Report on Consultation (Route Options)

Achany Wind Farm Extension Grid

Connection

REF: LT361/362

Plate 3.1: Preferred Route

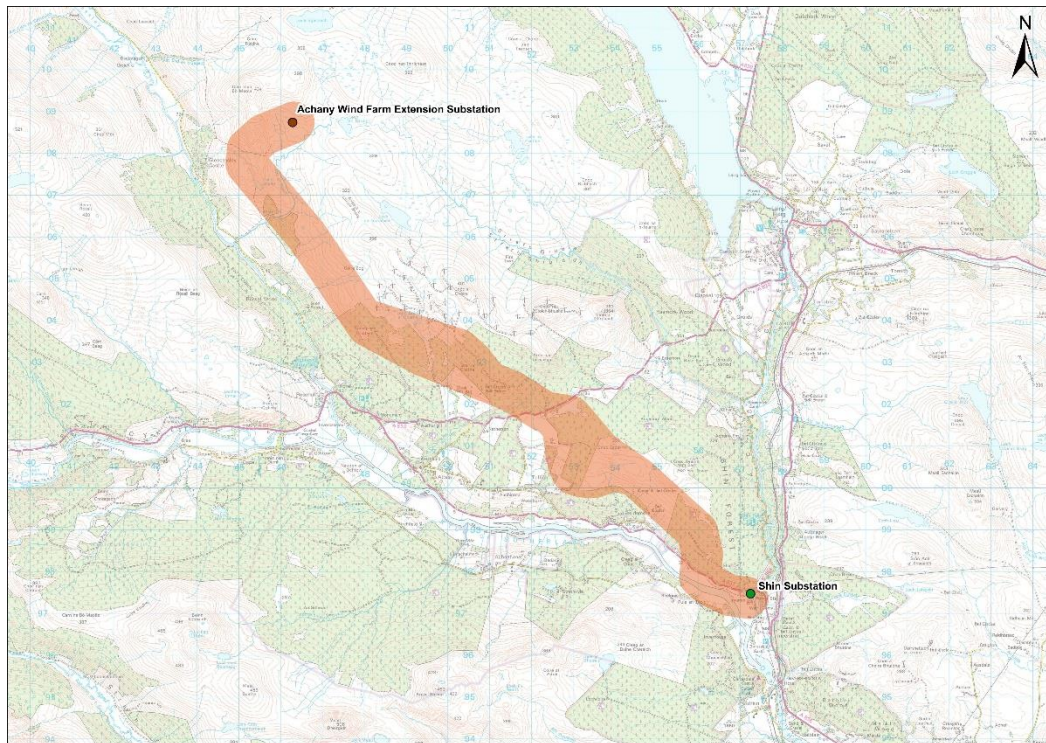
<p>HES agreed with the Consultation Document, in that, Route Option 1 and Route Option 1a could potentially have an impact on the setting of Invershin Farm, standing stone 220m ENE of (SM1791), with a greater impact caused by Route Option 1a as it would cross the Kyle of Sutherland in views upstream of the monument.</p>	<p>This has been noted. Route Option 1 was identified as the preferred route in the Consultation Document.²</p>
	<p>HES agreed with the Consultation Document, in that in relation to Route Option 2, small sections of the proposed OHL could be visible from Druim Baile Fuir, stone circle, cairns, hut circles and enclosure (SM 1784), but that this would be backdropped by the consented Braemore Wood wind farm, and therefore the change to the baseline setting would only be very slight.</p>	<p>This has been noted. Route Option 1 was identified as the preferred route in the Consultation Document.²</p>

<p>It was queried why Route Option 1a was included, as it is seemingly being dismissed, or removed as an option due to it coming across the Kyle of Sutherland SSSI.</p>	<p>Stage 2 (Route Selection) endeavoured to appraise a range of feasible route options between the two connection points at the proposed Achany Wind Farm Extension on-site substation to Shin substation.</p> <p>Due to constraints identified at the route selection stage, Route Option 1a is not considered the preference and will not be taken forward to Stage 3 (Alignment Selection).</p>
<p>It was mentioned that Route Option 1 passes close to several dwellings, which may be a concern to residents.</p>	<p>Any residents should have received information on the project by post and given the opportunity to raise their concerns.</p> <p>Proximity to dwellings will be considered further during Stage 3 (Alignment Selection) of the project and appropriate distances maintained as far as practicable.</p>

Title: Figure 1 - Proposed Route

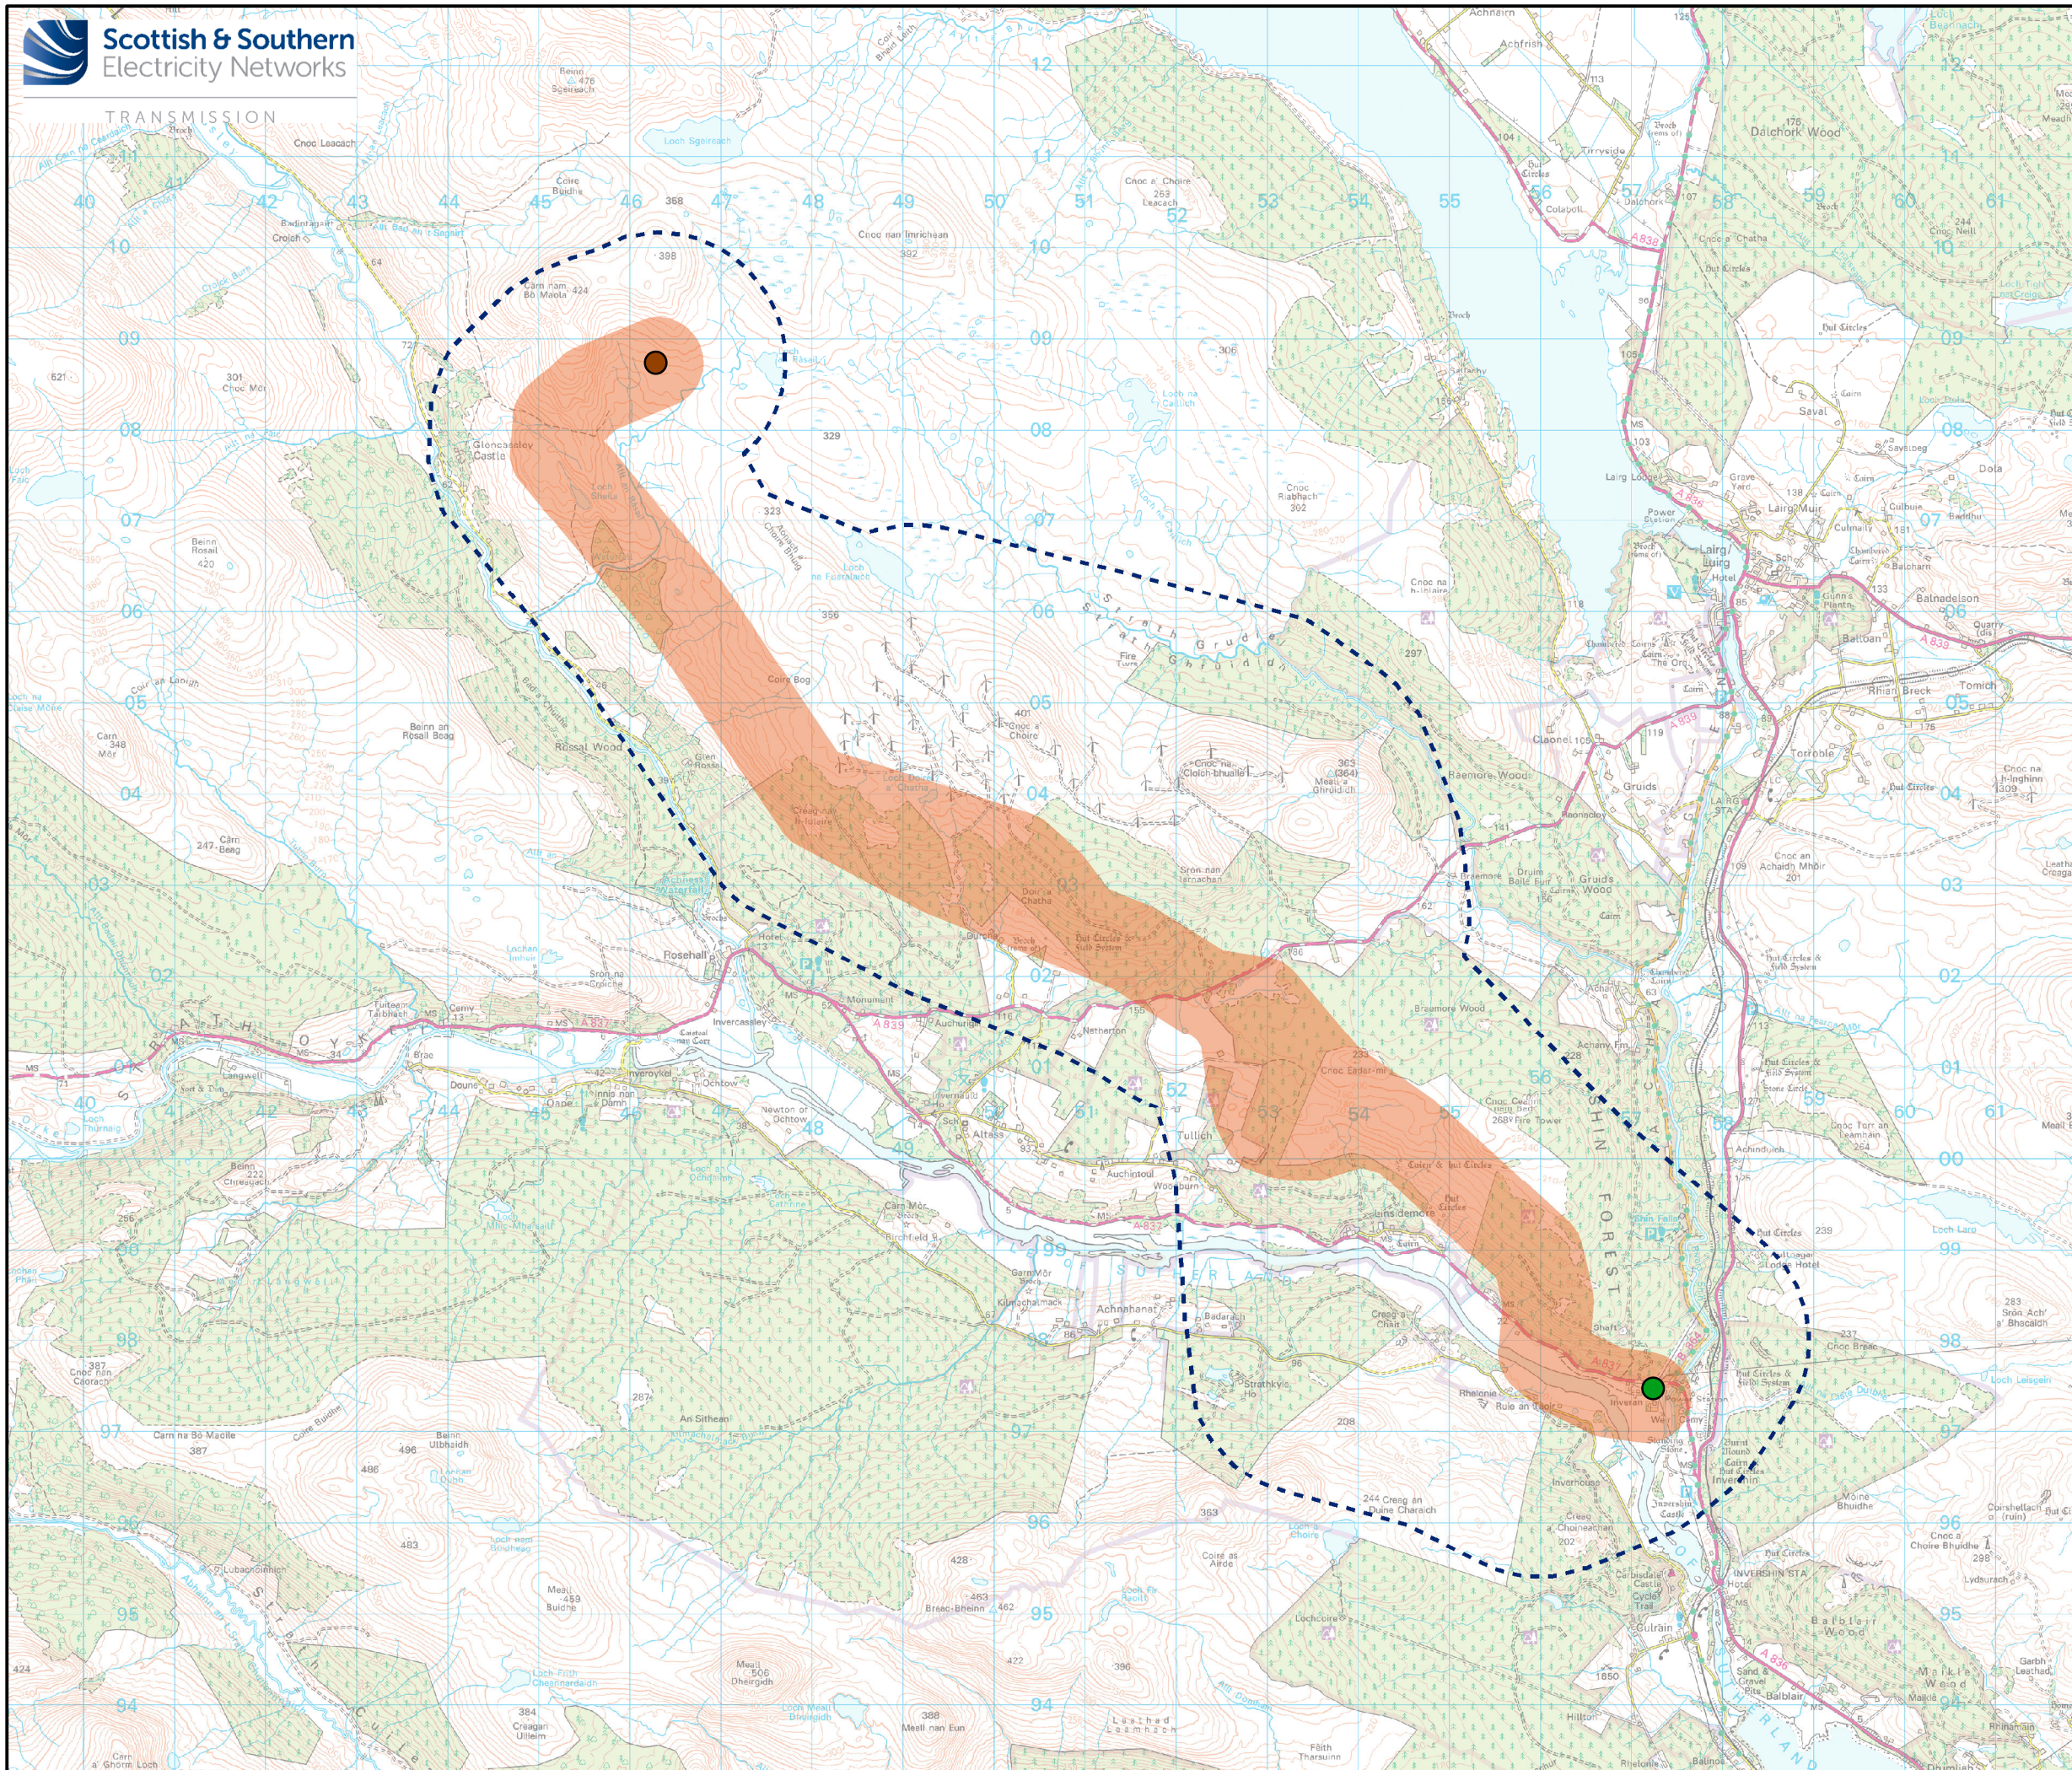
<p>HFL suggested that the route on the map is very wide, and it is therefore difficult to understand if the proposed development will affect them or not, they request further information regarding the exact routing if possible. HFL requested a clearer map in order to assess if an access agreement will be required between HFL and SSEN Transmission.</p>	<p>At this stage of the routeing process, route options are approximately 1 km in width. Once a proposed route is selected, alignment options are then identified and appraised within the 1 km route. Further consultation with HFL will be undertaken as the project progresses.</p>
	<p>HFL considered that the OHL may be an issue if the cables are particularly low as to restrict the type of vehicles they can bring onto their site. They believe there are guidelines for minimum heights. They would also expect 'goalposts' and extra</p>	<p>This would be discussed further with HFL during the alignment selection stage of the project to ensure HFL concerns are taken into consideration during the design of the project.</p>

7.1.2 SSEN Transmission has concluded from this review that the preferred route identified in the Consultation Document,² should be taken forward as the proposed route within which to identify and appraise alignment options. The proposed route can be seen in Figure 1.
